PRINCE HALL (DX-3-DE)

Nature of Project:
Construct rear addition;
remove front porch steps;
construct new front porch steps

APPLICATION FOR A CERTIFICATE OF APPROPRIATENESS – STAFF REPORT

COA-0142-2019 323 E CABARRUS STREET

BUILT MASS DIAGRAM

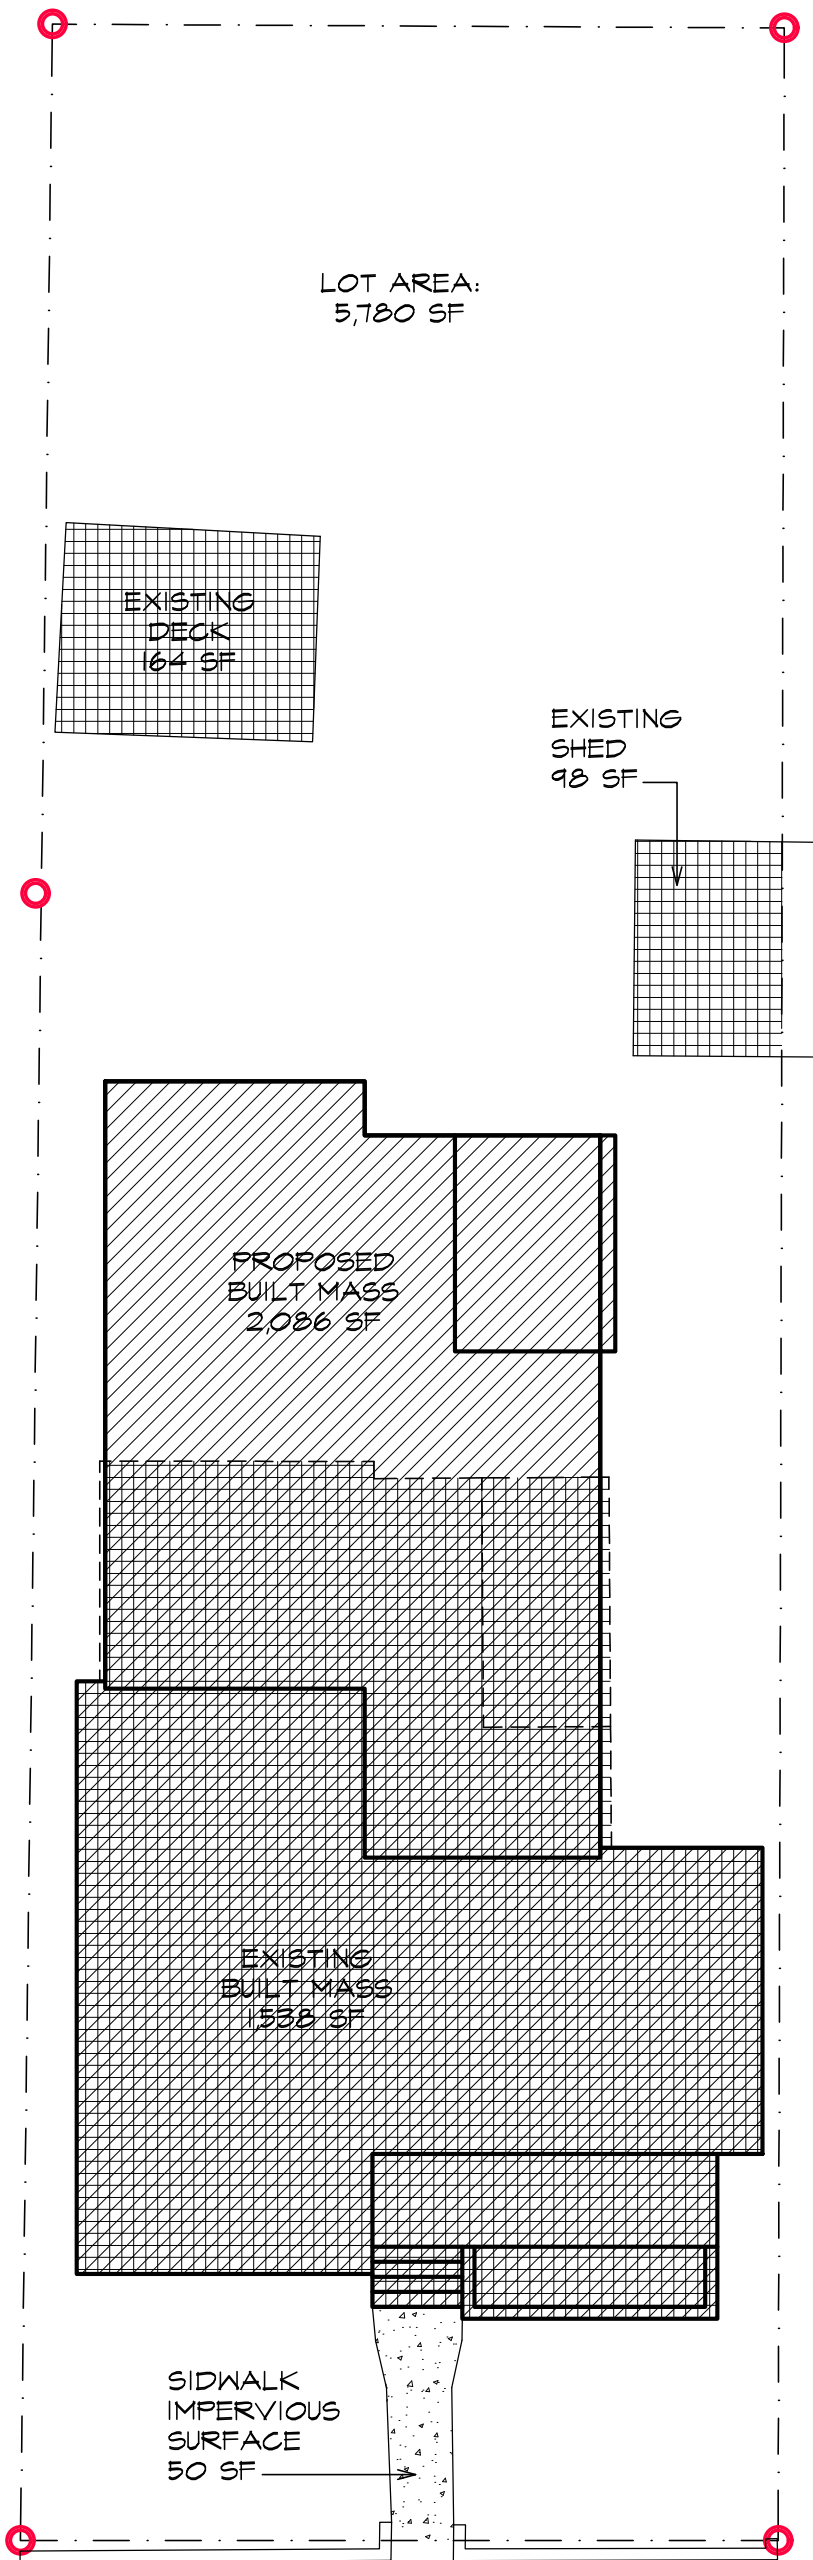
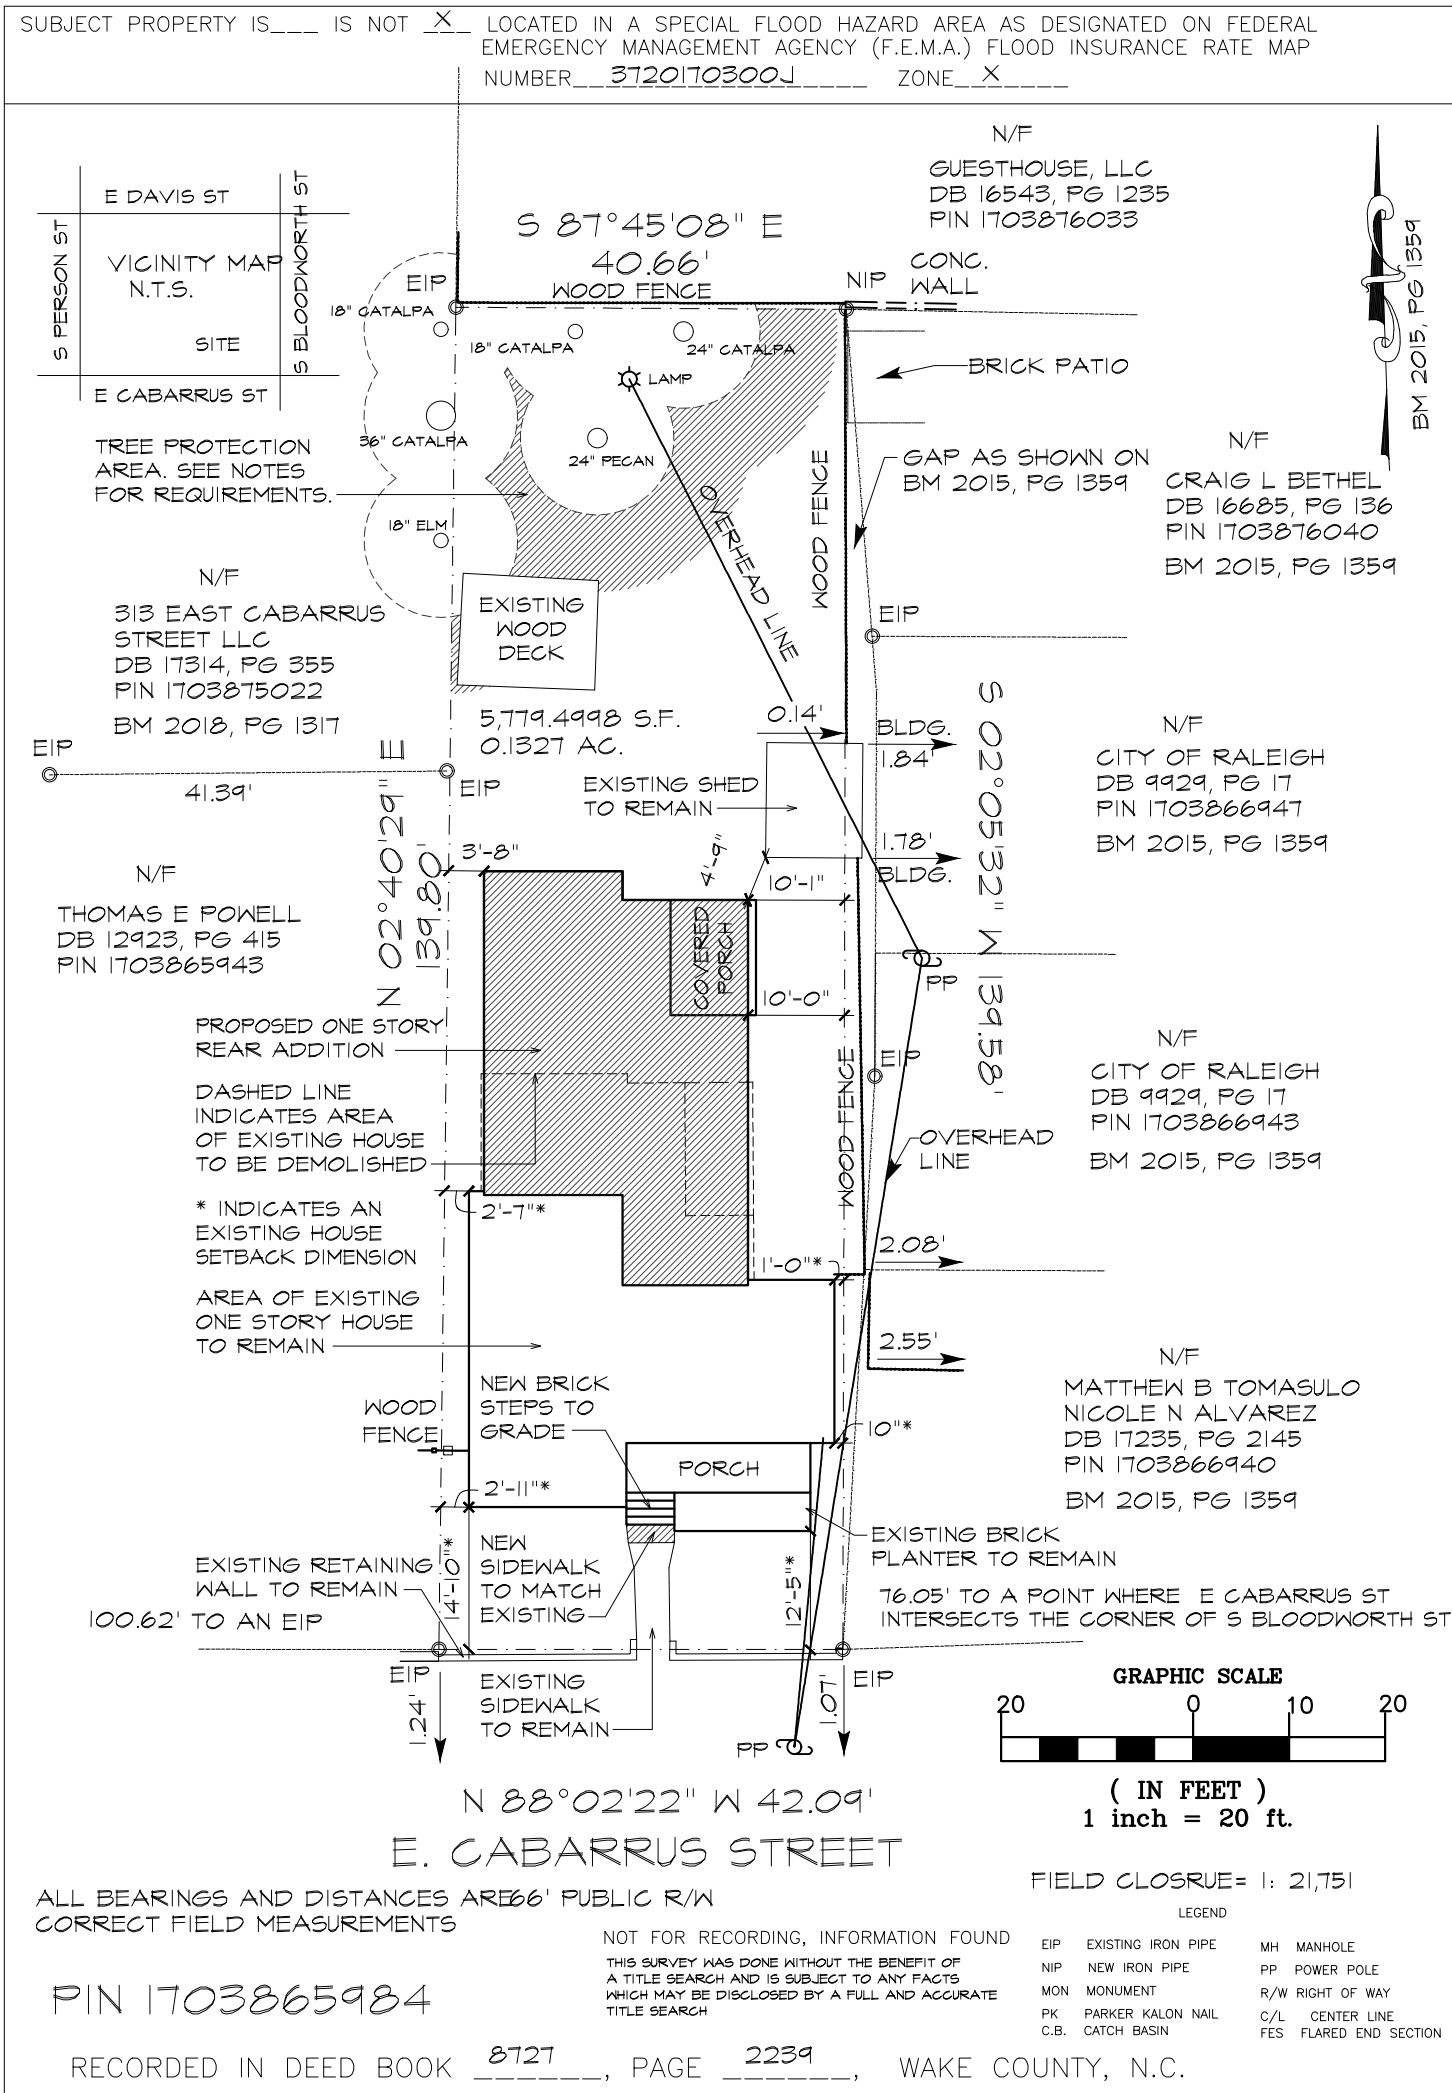
- 15* The application includes the following built **area** to open space analysis: The lot is 5,780 SF. The **existing** built area is 1,841 SF, or 31.8%. The proposed built area is 2,398 SF, or 41.5%. This is an increase in built area of 9.7%.

- 16* The application includes the following built **mass** to open space analysis: The lot is 5,780 SF. The **existing** built mass is 1,538 SF, or 26.6%. The proposed built mass is 2,086 SF, or 36.1%. This is an increase in built mass of 9.5%.

- 17* The Design Guidelines refer to the **original** built mass to open space stating, "It is not appropriate to construct an addition that significantly changes the proportion of original built mass to open space on the individual site." Calculations were not provided for the property's **original** built mass.

- 18* The application includes the built area percentages for two nearby properties. Both examples have a greater built area than the proposed.
- 19* Windows on the addition are proposed to match the existing double-hung 3 over 1 windows. One suburban style clerestory window is proposed towards the rear of the addition on the west façade. Specifications were provided.

Staff suggests that the Committee discuss the increase in built area/built mass. Pending the results of that discussion, staff recommends the Committee approve the application with the following conditions:

PROPOSED PLOT PLAN

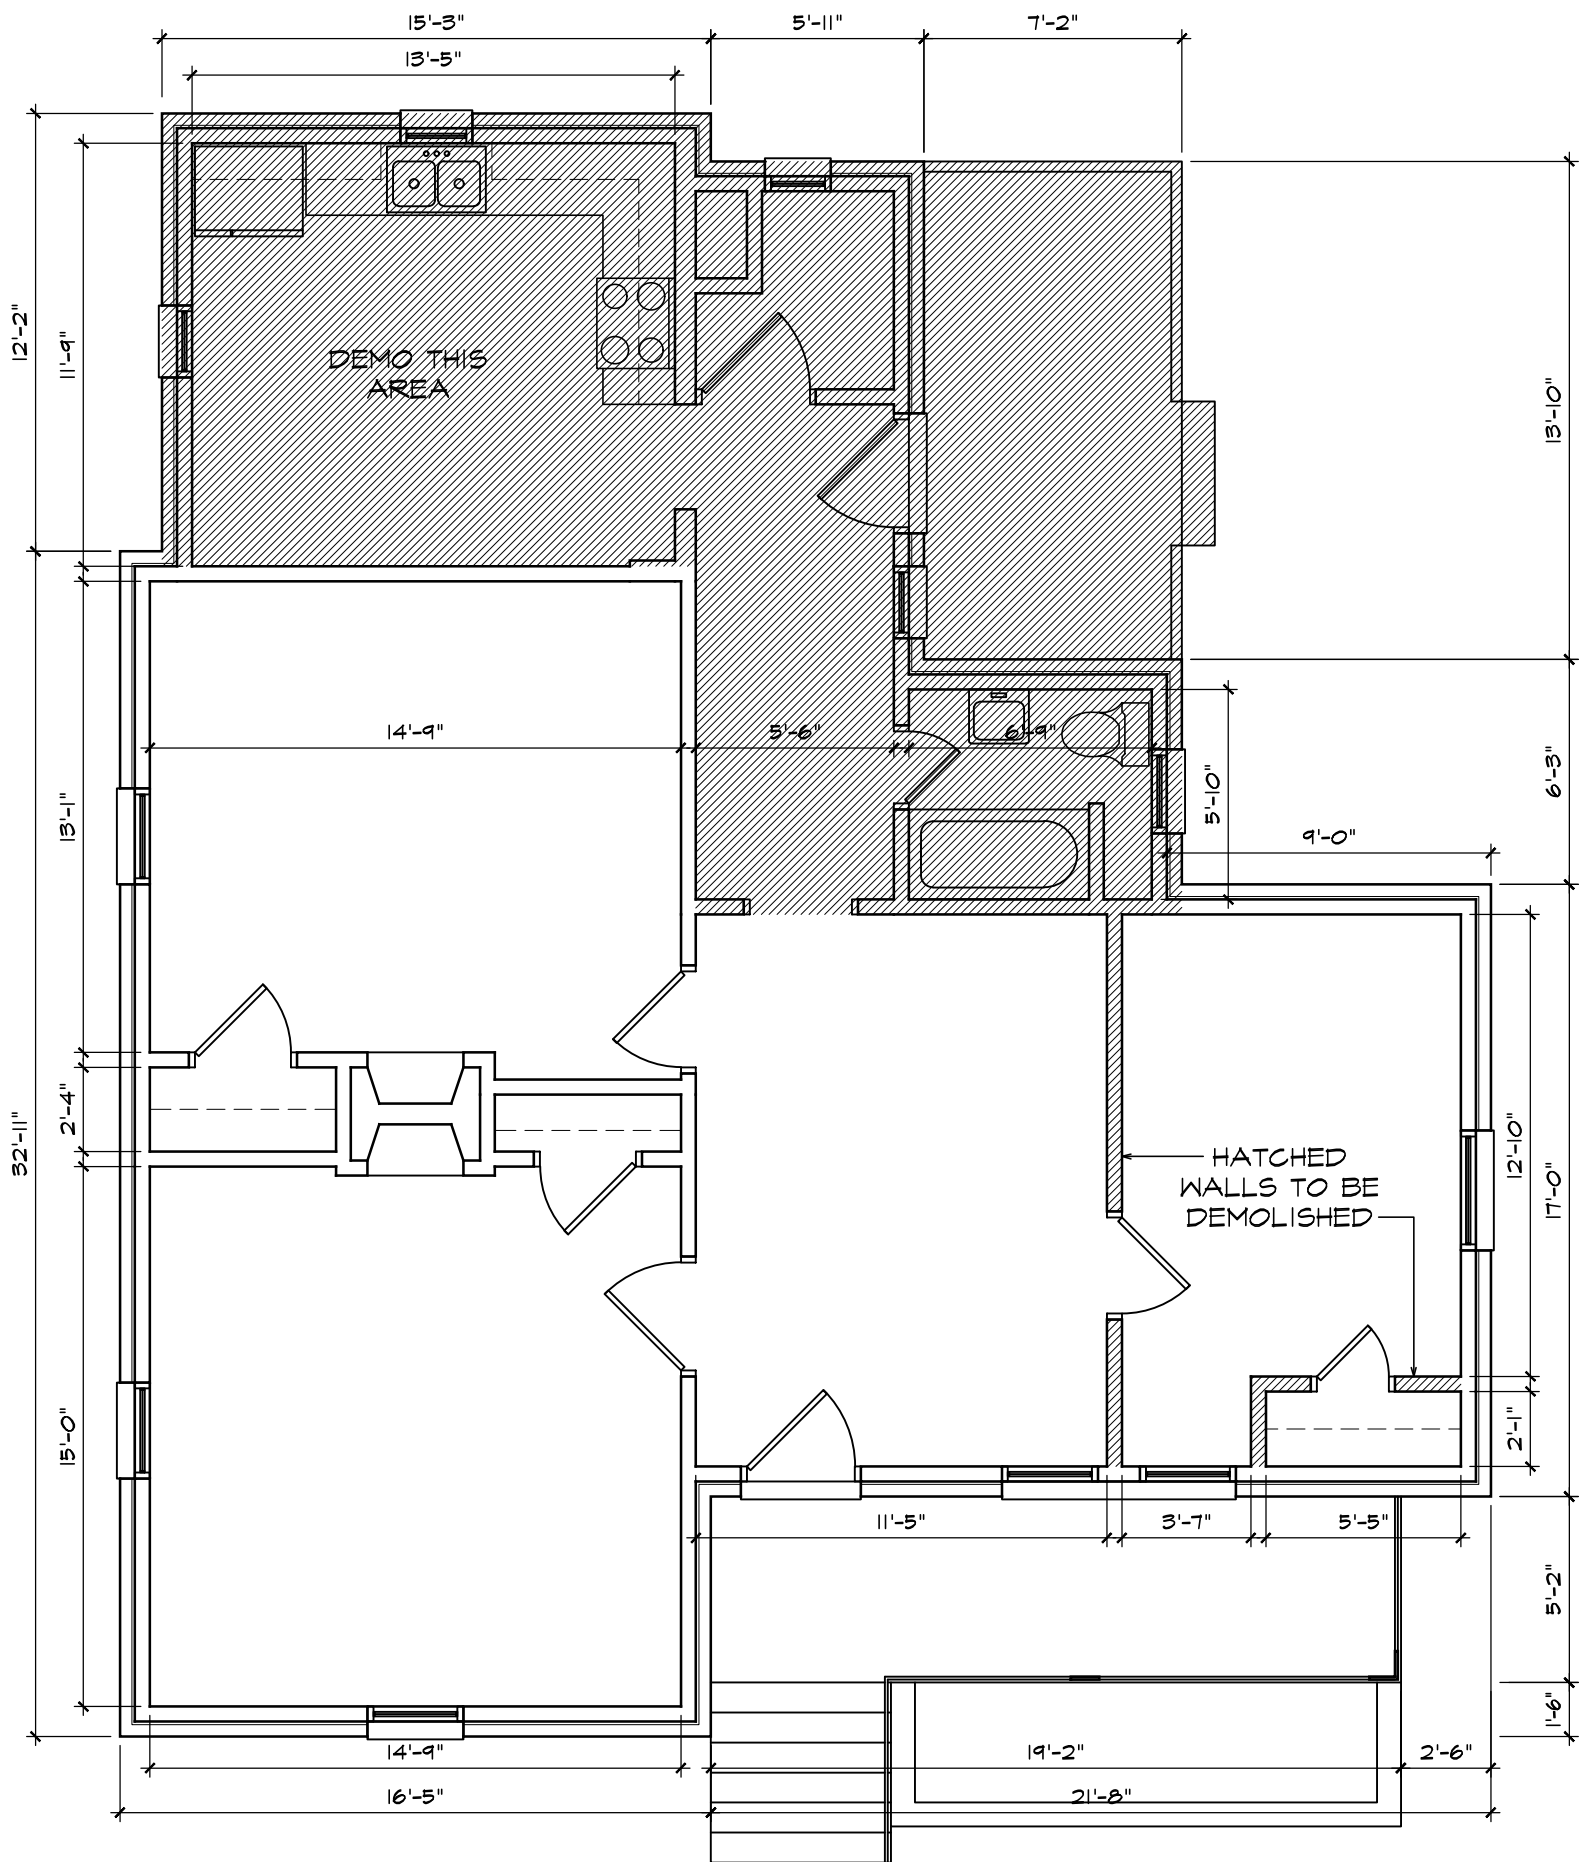
- 23* The application states that all trees larger than 7" DBH will remain and be protected. The application indicates that no tree roots are located in the area of construction. A tree protection plan was provided.

- 24* No information was provided on construction access or material storage. Due the location of the house, it appears that access would need to be from the adjacent City-owned properties.

1. That all fiber cement elements on the addition be installed smooth side out.
2. That details and specifications for the following be provided to and approved by staff prior to the issuance of the blue placard:
 - a. Eave details.
 - b. A revised tree protection plan noting material storage and construction access.
3. That details and specifications for the following be provided to and approved by staff prior to the installation or construction:
 - a. Manufacturer’s specifications for paint;
 - b. Locations of gutters and downspouts;
 - c. HVAC location and screening;
 - d. Exterior lighting.
